DATE: September 20, 2023
TO: Franklin Planning Board
FROM: Department of Planning and Community Development
RE: 341 Union Street St
Field Change

SITE PLAN
 PROPOSED REVISIONS
 341 UNION STREET
 FRANKLIN, MASSACHUSETTS

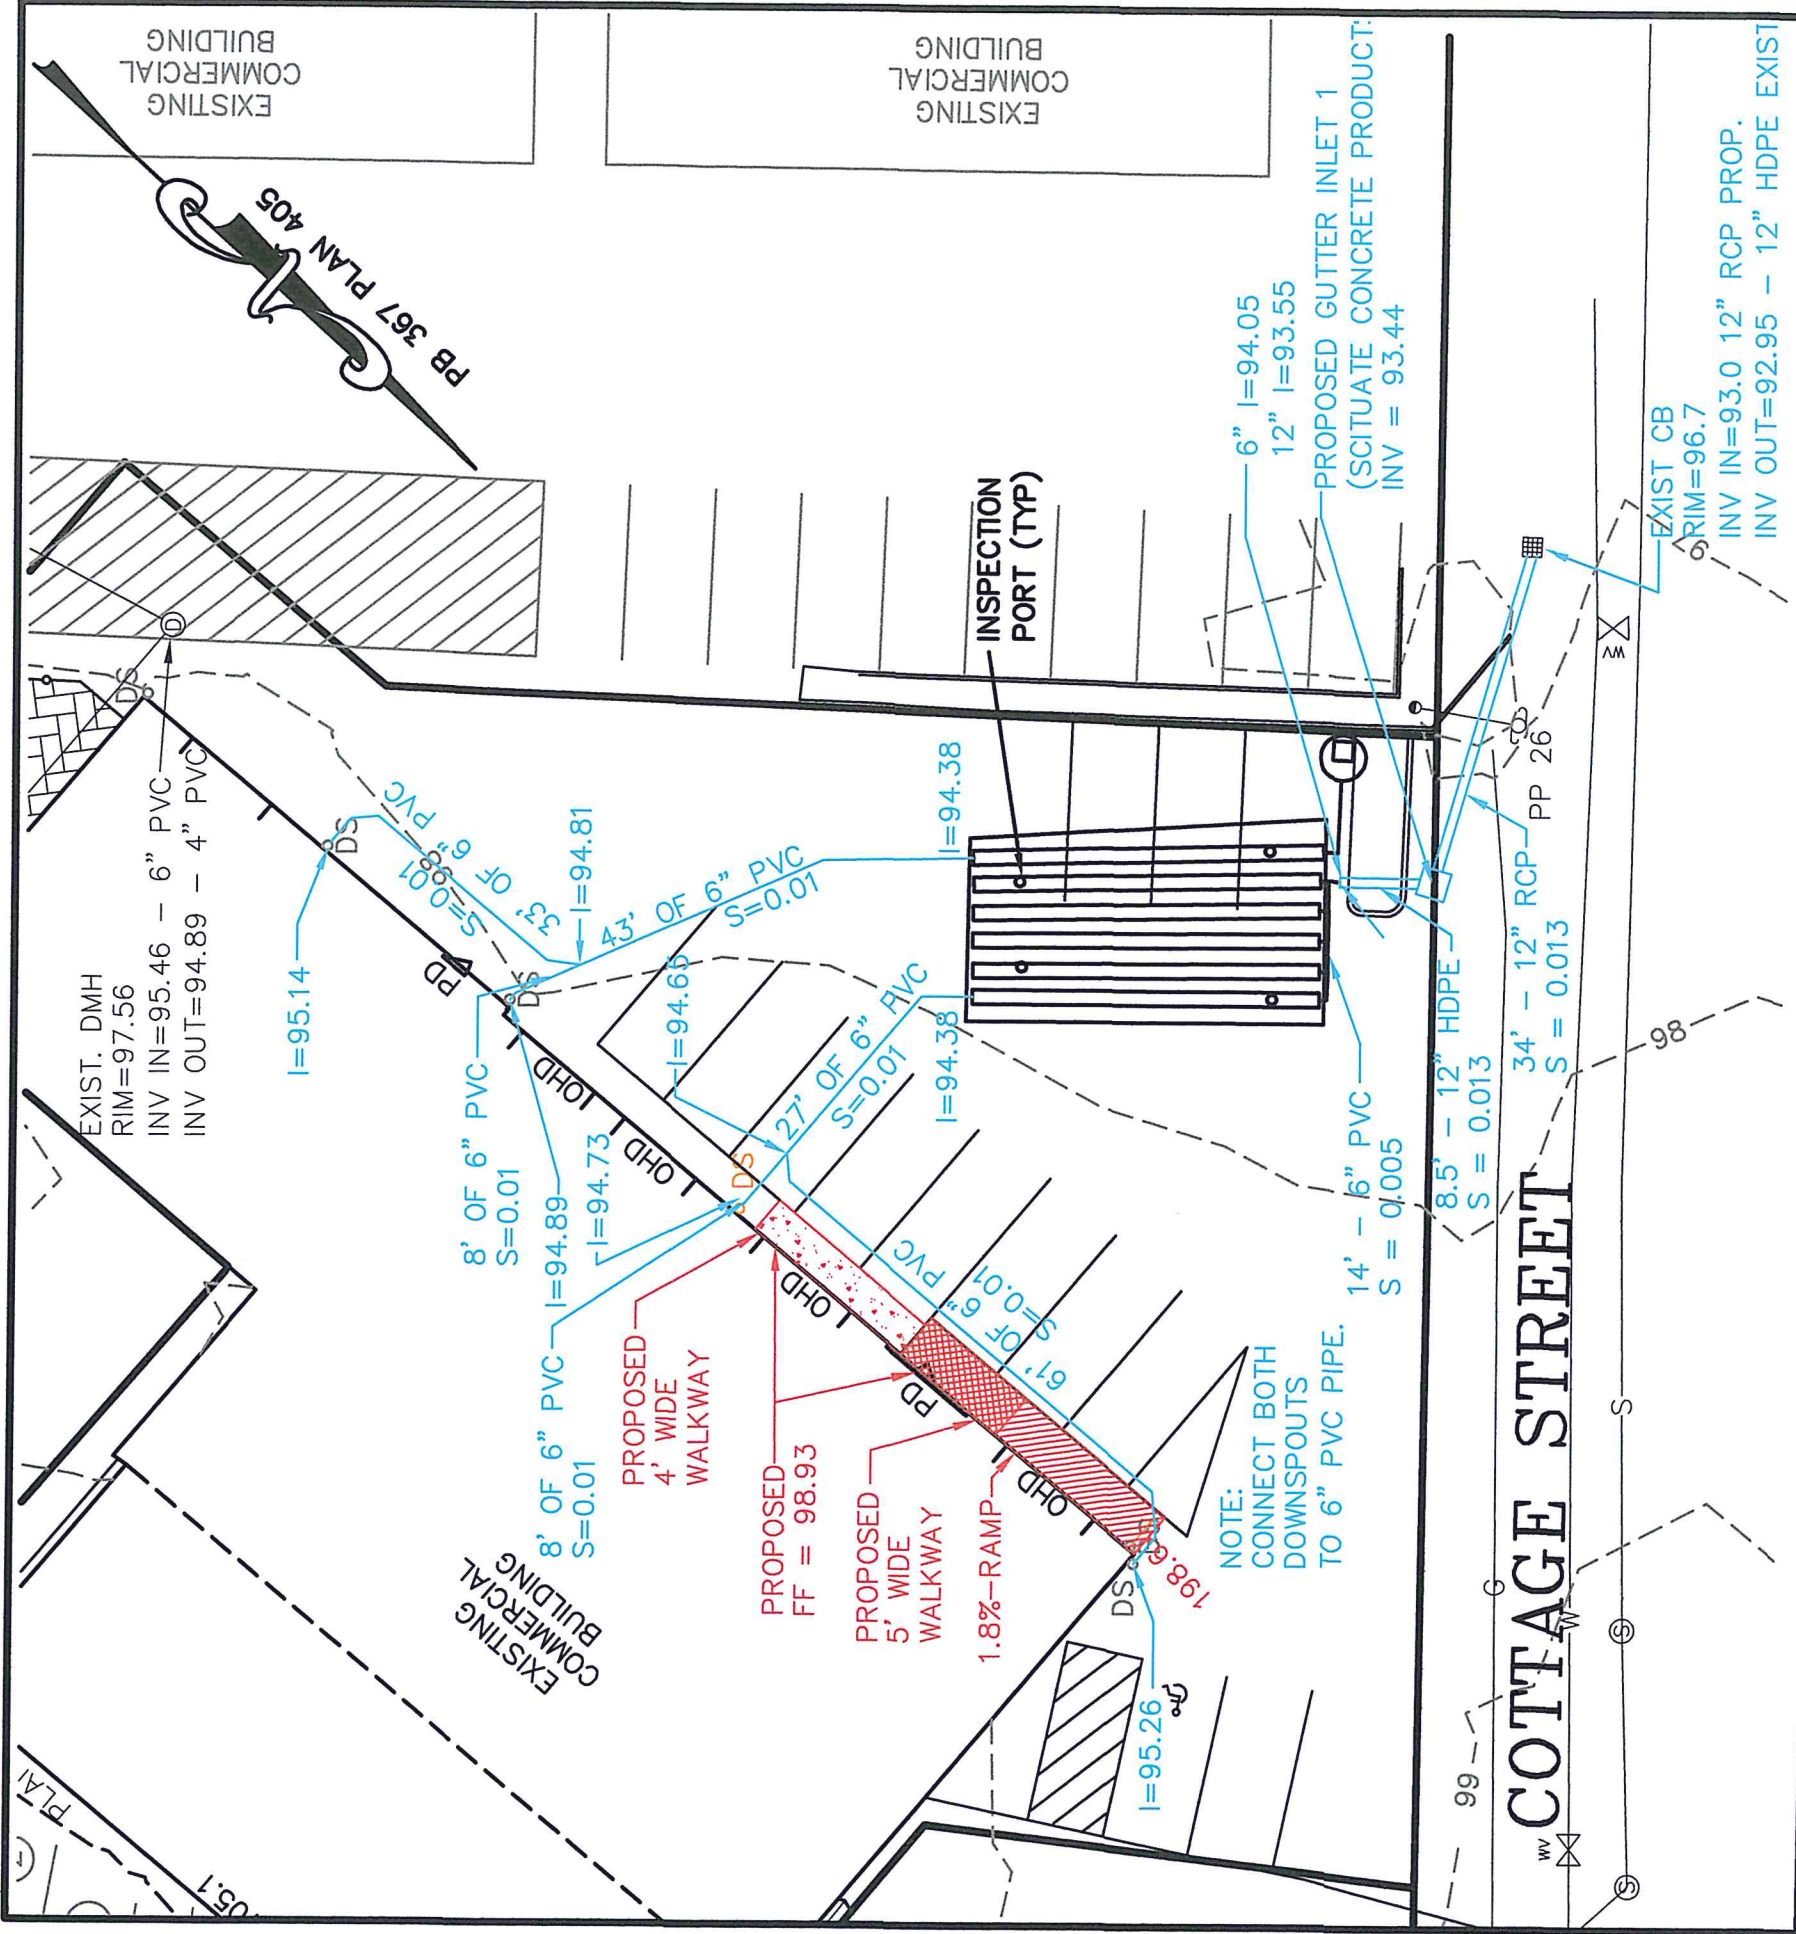
Attached is a diagram for a field change at 341 Union Street. The applicant is proposing to extend the sidewalk along the front of the building. The current proposed sidewalk is 5ft wide and the extended sidewalk will be 4ft wide. DPCD felt this should be brought the Planning Boards attention prior to the Final Form H being submitted.
